PD Modification Application 21-0255

**Hillsborough
County Florida**

Development Services Department

Request Minor Modification of PD

2.5 Proposed Site Plan – Option 1 Non Residential Single Use

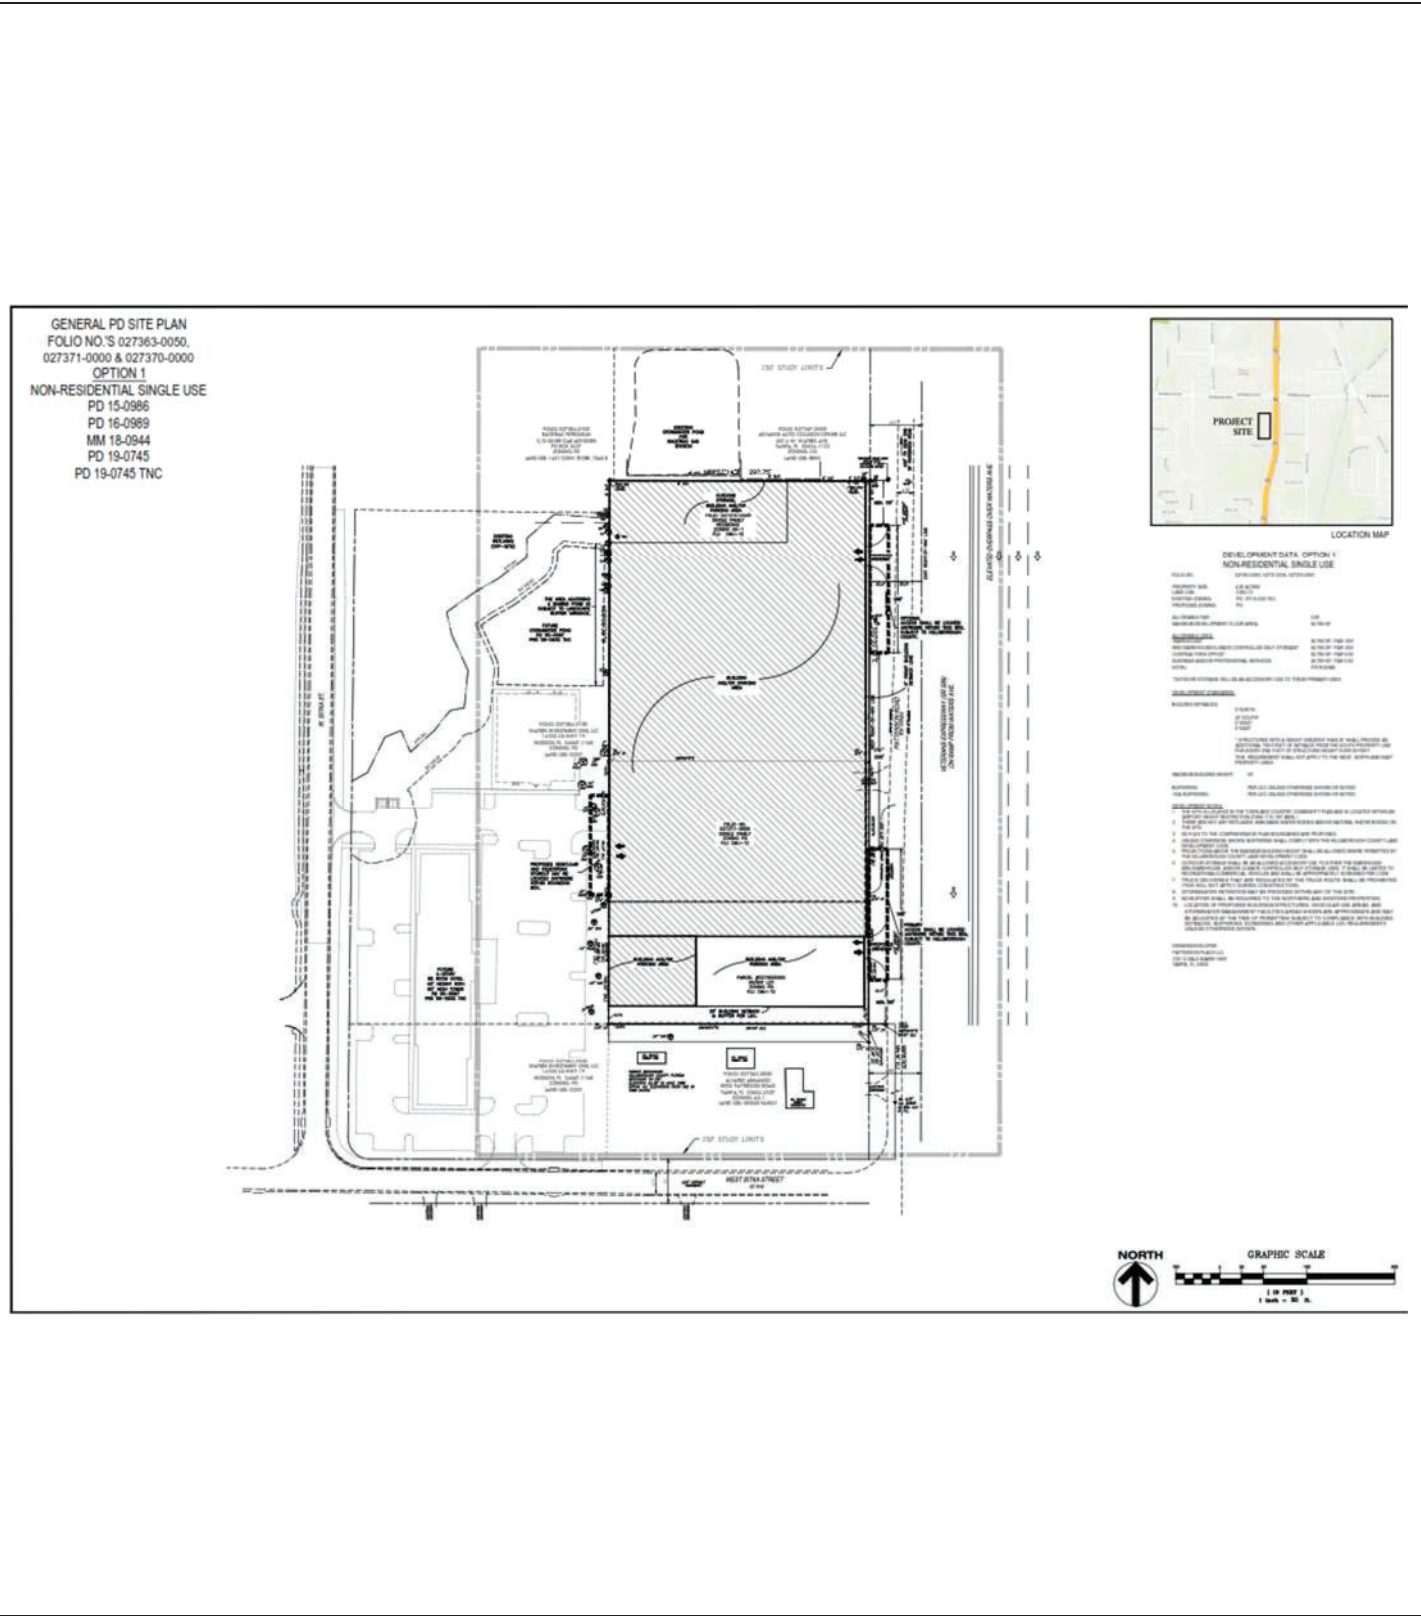
- Add note to all site plan development options that “All existing driveways shall be removed.”
- Add note to all site plan development options that “All internal circulation shall be served by private driveways.”
- PD site plan option 1, 3 and 4 Allowable Uses to state “Business and/or Professional Services (excludes Medical Offices and Clinics)
- PD site plan option 3 and 4 Allowable Uses to state “Retail Uses allowed within the CD district (maximum of 5,000 Square Feet)”

2.5 Proposed Site Plan – Option 4 Residential Mixed Use

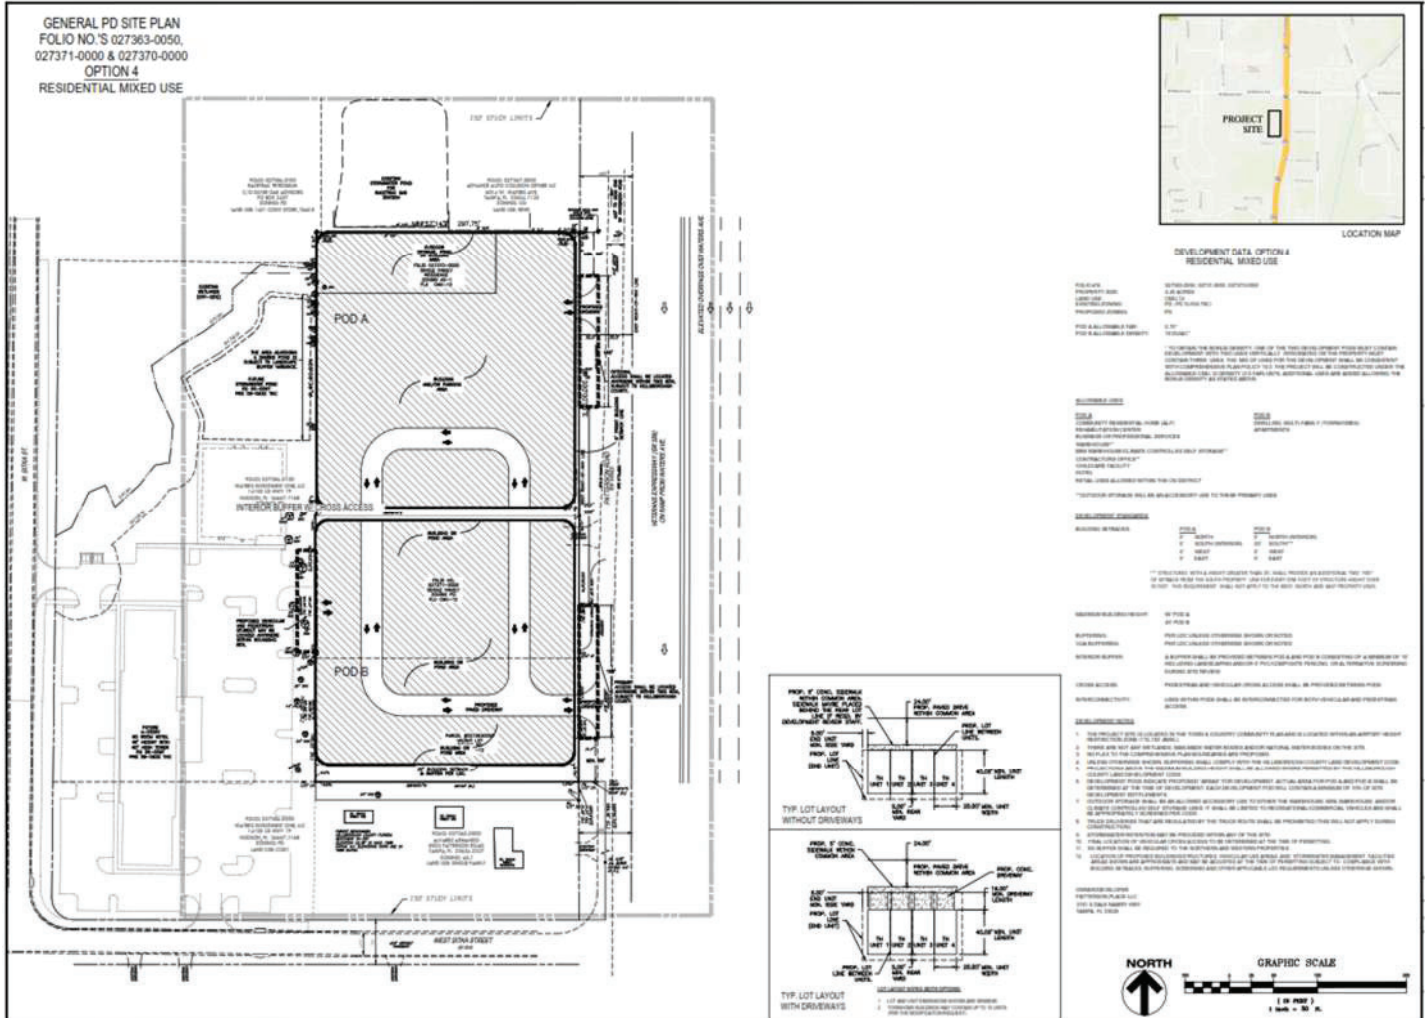
The site plan option 4 includes an internal road connection between Patterson Rd. and the adjacent Planned Development (MM 19-1329) to the west. If site plan option 4 is constructed, the developer shall construct sidewalks on both sides consistent with LDC, Section 6.02.03. A.
